**NO:** LS-080                      **PRODUCT:** D4BL Safety-door Switches  
**DATE:** October 2015            **TYPE:** Modification Notice

## D4BL Safety Door Switches will be Modified for Improved Indicator Visibility

**Effective date:** April 2016 production

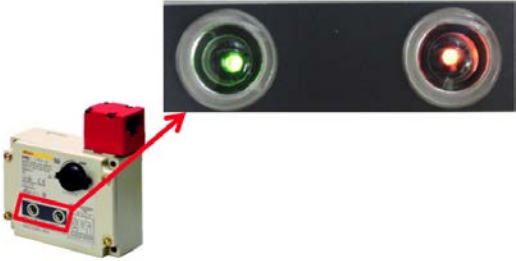
The brightness of the Green and Orange LED switch status indicators will be made at least four times brighter to improve visibility.

Before the change	After the change
<p><b>Indicator</b></p> <p>Low luminance LED                      Luminous intensity:                      Orange: 24 mcd                      Green: 24 mcd                      (representative value)</p> 	<p><b>Indicator</b></p> <p>Indicator becomes brighter.                      High luminance LED                      Luminous intensity:                      Orange: 350 mcd                      Green: 100 mcd                      (representative value)</p>
